Consumer Product Service
Manager of Tehnical Support
FIELD- CHANGE ORDER number 1

MODEL: Atari 810 Disk Drive

Rear Board, Molex Connectors Removal

Consumer Product Service
Manager of Technical Support
UPGRADE BULLETIN

Silkscreen 810 Side Board

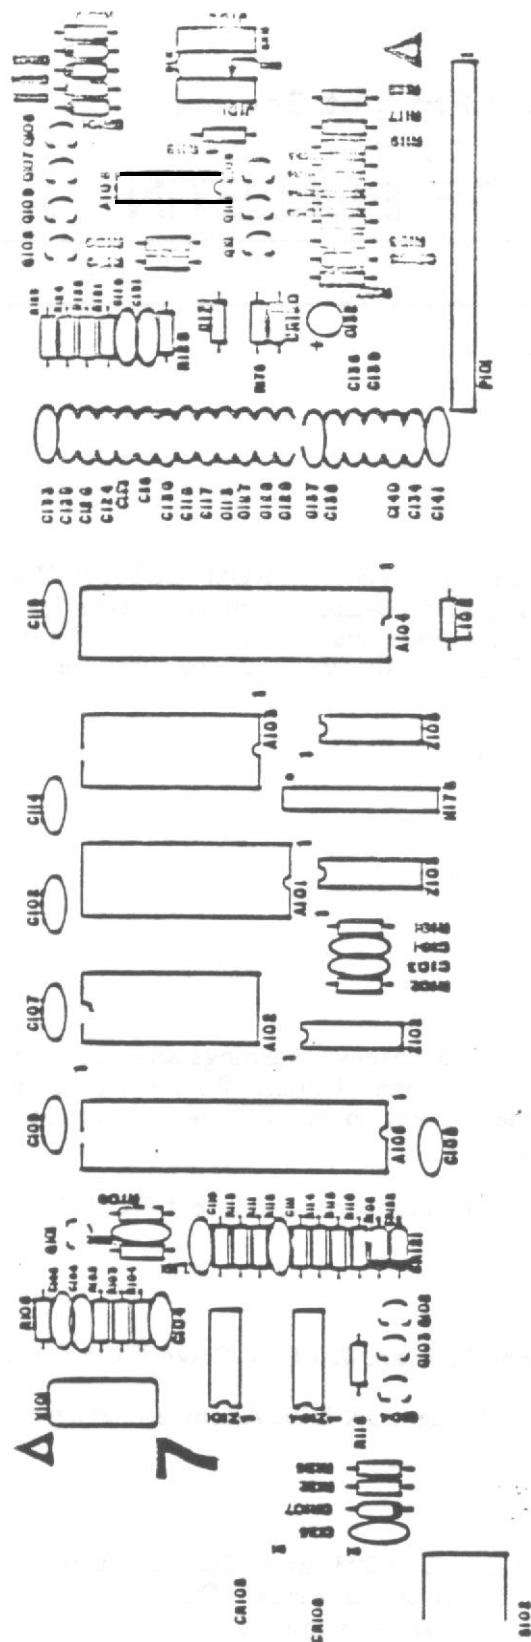
New units manufactured by Atari contain a Revision C ROM (**CO11299C**) on the sideboard (**CA014834**). This new ROM improves diskette sector layout and gives faster access time. Consumers may wish to replace old ROM revisions (**CO11299B**) with Revision C ROM for improved Disk Drive performance. This Upgrade Bulletin instructs **Service** Dealers who install this component.

Part Location - Sideboard, **CA01 4834**
Location **A102**

Remove **CO11299B** from Location **A102** on sideboard, and insert **CO11299C**.

810 Rear Board
Silk Screen

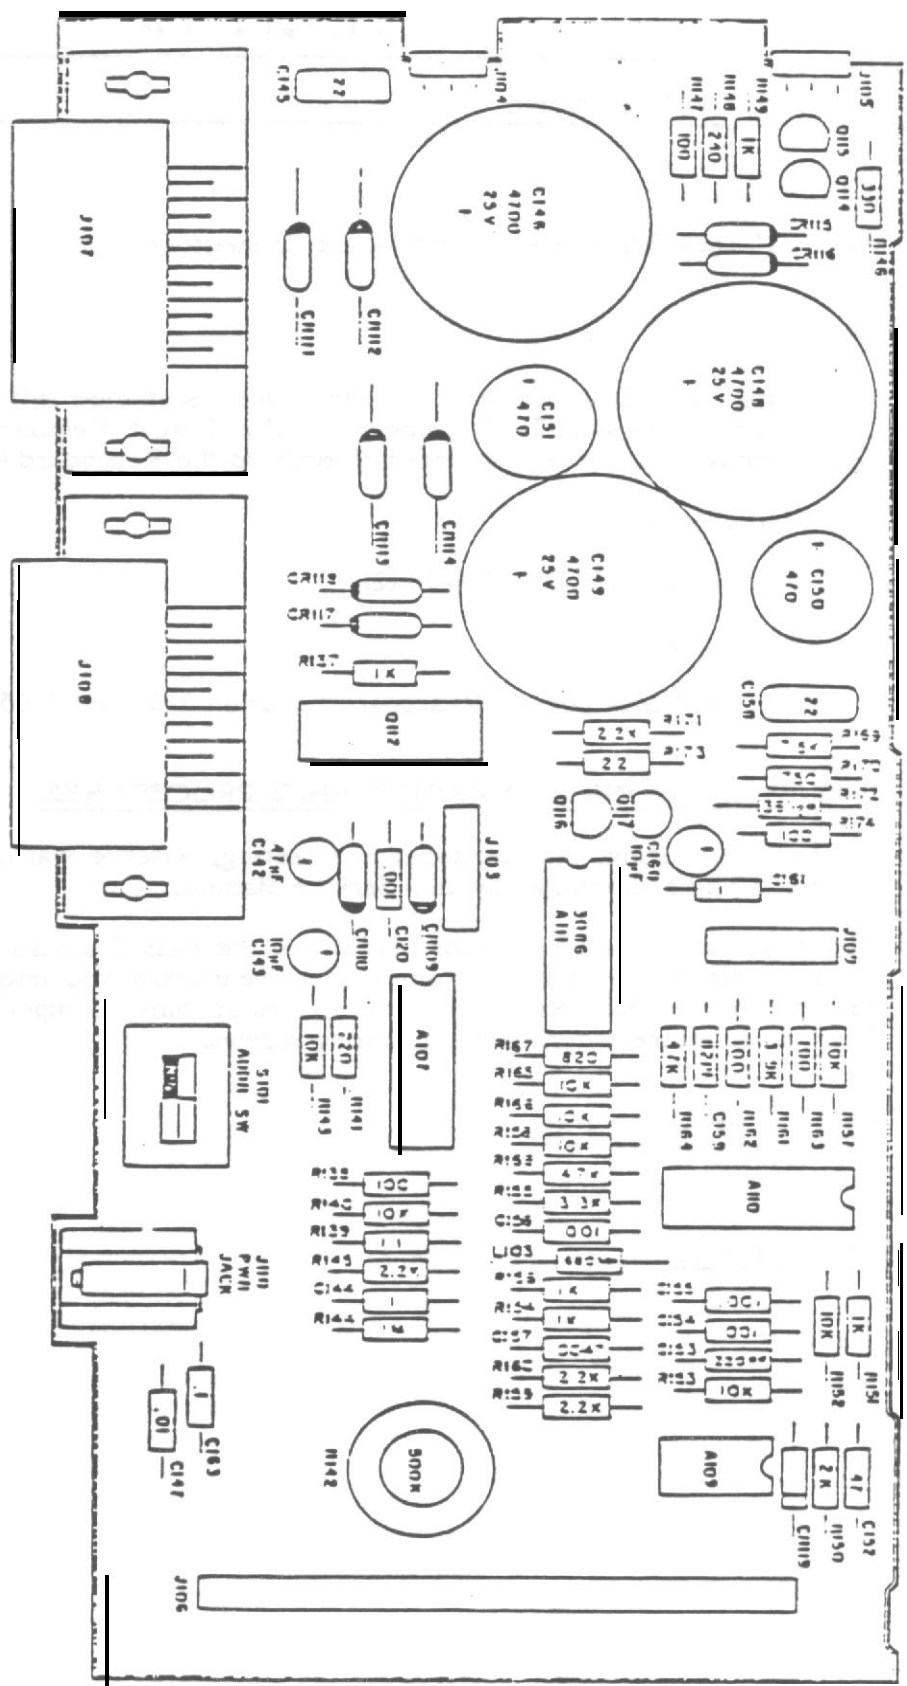
New Atari 810 Disk Drive Rearboards are assembled with the two 3 Pin Molex Connectors (J104 and J105) removed. The 5 Volt Regulator (A108) and the Pass Transistor (Q113) are now soldered directly to the Rearboard (see Sii Screen an back).

810 Disk Drive - Rearboard Lacarian J104 and J105.

Note that the Voltage Regulator (A108) and the Pass Transistor (Q113) are fastened to the base plate. In order to remove the Rearboard you must remove the mounting screws from each. Remember to use Heat Sink Compound when replacing the Rearboard, before securing the mounting screws.

810 DATA SEPARATOR SILKSCREEN

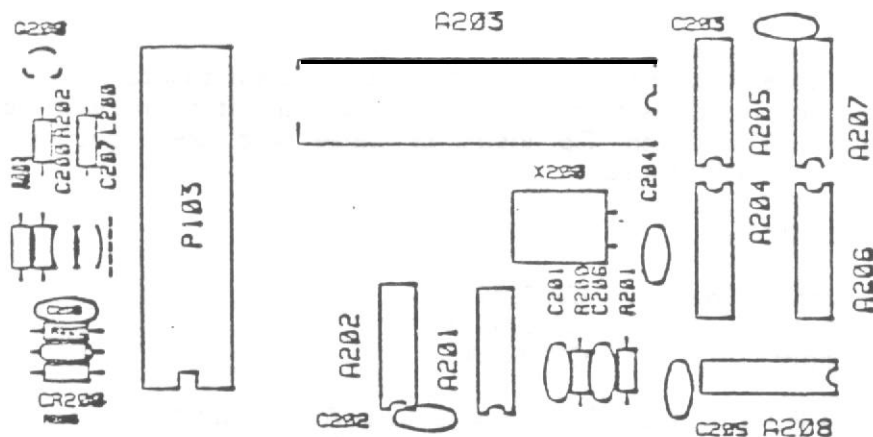
Part Location - P103 on Data Separator Board, Atari Part No. CA017231, plugs into the sideboard location A105 on Atari Sideboard Part No. CA014834, where FDC 1771 (Floppy Disk Controller) is usually installed.

NOTE: These boards cannot be installed in the existing socket in sideboards not designed for data separator. Doing so may result in short or intermittent failures.
